PLANNING COMMITTEE – 3 JULY 2018

Application No:	18/00125/FULM (MAJOR)	
Proposal:	Proposed conversion of Hatton House (formerly Newark Working Men's Club) Beacon Hill Road Newark, to form 8 apartments. Remainder of building to be demolished. To include erection of 8 new cottages and associated access and landscaping works.	
Location:	Newark Working Men's Club, 13 Beacon Hill Road, Newark On Trent	
Applicant:	Northgate Lettings	
Registered:	31 January 2018	Target Date: 01 May 2018

Basement

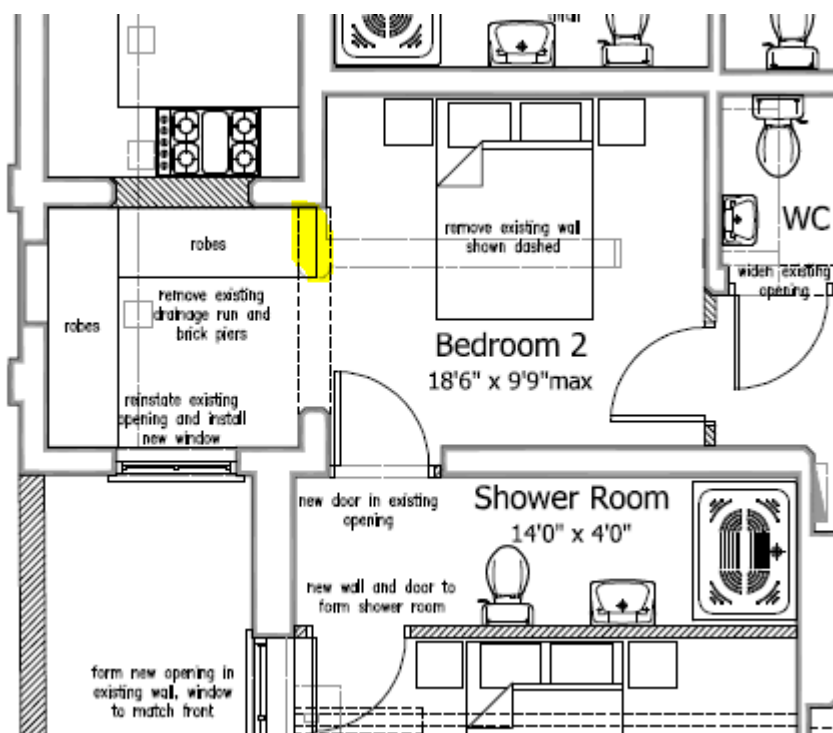
One of the main changes to the basement is the reinstatement of the windows here, which can be seen surviving, albeit in a derelict and blocked in form. These were reasonably formal sash windows and show that the basement was used as living accommodation in some form. Their reinstatement and the better use of the cellar will be a positive heritage gain for the building. I do

In terms of plan form, the overall existing layout is actually quite well preserved in the proposed plans. I note one of the small store rooms is being removed to create a larger room, but appreciate the re-use of the adjacent store room as a shower and another as a kitchen.

There is one small area, see plan extract below, where an attractive rounded arch is being removed to create a wider entrance to a wardrobe area. Given the use of this space there is no need for this removal of fabric and the arch should be retained.

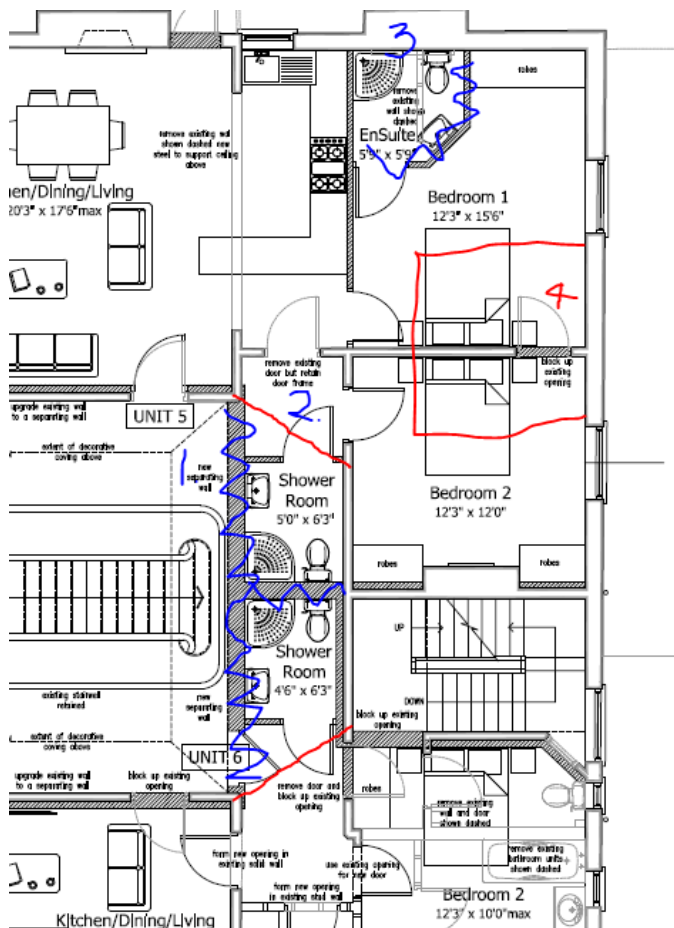
The main alteration here is the reinstatement of the grand, staircase down from the first floor level. This will be a significant heritage gain and improvement to the aesthetic significance of the building as well as making the plan form more legible. I understand new decorative metal stair rods would be cast to match, though this detail should be conditioned. Now that the suspended ceiling over the bar has been removed the decorative coving is now revealed and while it will **need repair (to be conditioned)** it is relatively well preserved and mostly capable of repair. **The treatment of the tiles in the hallway, as well as the spec for coving repair, should also be conditioned.** This should secure a significant heritage gain for this building.

In order to divide off the separate residential units from this communal hallway I appreciate that a new inner hall is to be created, to allow not just access into the flats but access *within* the flats to different rooms. This seems like an acceptable compromise and the original hallway will still be retained in plan but **the retention of a downstand** where historic walls are being widened out should be conditioned, as this will make the plan form more legible. I understand the **new inner hall can sit just within (and therefore not harm) the moulding on the hallway ceiling, but again this detail could be secured by condition.**

The front rooms are the only rooms which retain their original proportions, though with no fireplace or chimney breast. While the left hand room will be partially opened up to create a kitchen/diner the original layout can be read by conditioning a downstand, and is a 'trade-off' for the re-formation of the right hand room.

The removal of the rear extension gives the opportunity to re-form the original position of the back wall. While these back rooms are to be then subdivided they have long since lost any significance by the wholesale opening up which occurred in the 1960s/70s, so I have no objection to their subdivision and think there is still overall heritage gain by re-forming the original position of the back wall.

Please see my annotated floor plan for suggested amendments to the first floor:

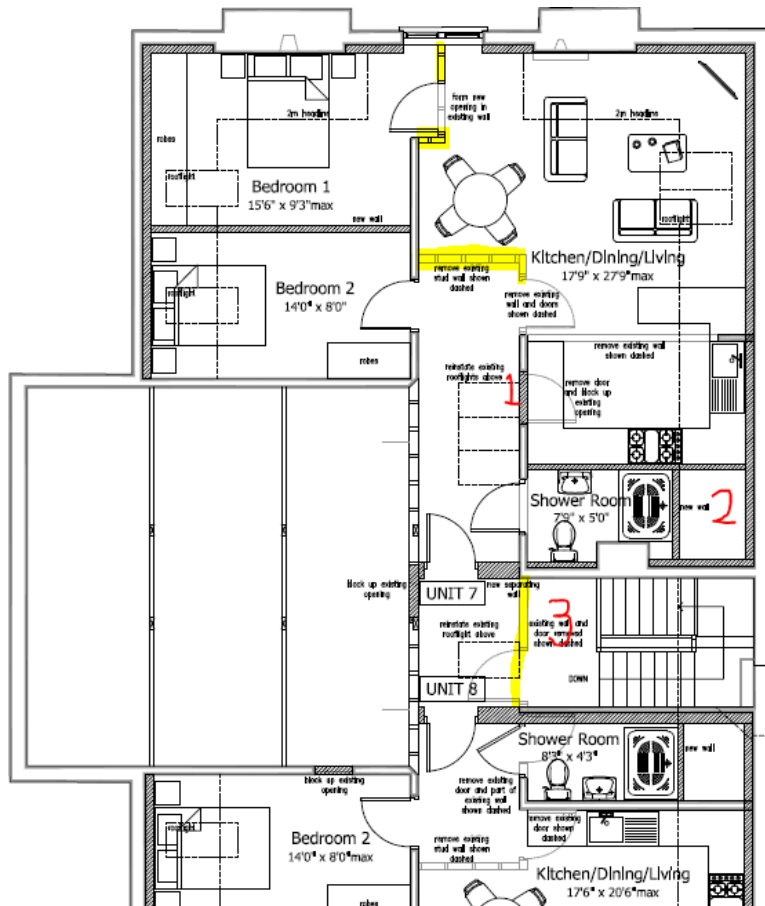
My main issue with this first floor layout is the way the reinstatement of the grand staircase will be compromised by bringing forward rooms right up the banister, removing the landing, as marked with the blue zigzag line and number 1. This will crowd the staircase and undermine the ostentatious sense of space (and circulation) that it was designed to bring. I have spoken to the owner about this specifically and accept there needs to be some form of easement to keep access across the landing to the flats, but that this can be achieved by a chamfered corner, as marked number 2 above, leaving most of the original landing open. This will complete the positive impact of reinstating the grand staircase.

I am also not happy at the proposed ensuite across a fireplace (marked number 3 above). I do appreciate an existing inappropriate stud wall here, but the removal of this and reinstatement of the fireplace as a proper feature will be a positive enhancement which could be achieved here. The compromise is the need to achieve bathroom space and I feel this is best achieved by creating a 'Jack and Jill' style arrangement as marked number 4 above. Overall, I think this will be a better arrangement than is currently at the building and a reasonable compromise moving forward. What we didn't discuss on site, but which could be looked at, is whether the floor to ceiling height is such that this ensuite could be formed more as a pod, sitting under the original ceiling height allowing the original layout of the room to be read. The other option, which was used at St Pancras Station Hotel and put forward in the recent Kelham Hall application, is to create a bespoke bed which has an ensuite behind, almost like a fitted wardrobe, although I appreciate this may be more appropriate for hotels than for residential properties.

I also note there are various areas of internal lining to improve acoustic qualities between separate units. While this is an otherwise unwanted intervention the room proportions are such that this can be achieved with no perceptible alteration but I would ask that the **coving, skirting and picture rails be reformed and secured by condition.** It is a better compromise to have this

lining within the living areas, rather than on the staircase and landing, and so overall I have no objection to this intervention. Equally bedroom 2 of unit 5 sees lining either side of the chimney breast, but the reveal is deep enough here to allow for this with no perceptible loss of the chimney breast projection. **I would ask that the annotation marked robes either side of this chimney breast not rise to full ceiling height, allowing the dimensions of the chimney breast to be read, again to be secured by condition.**
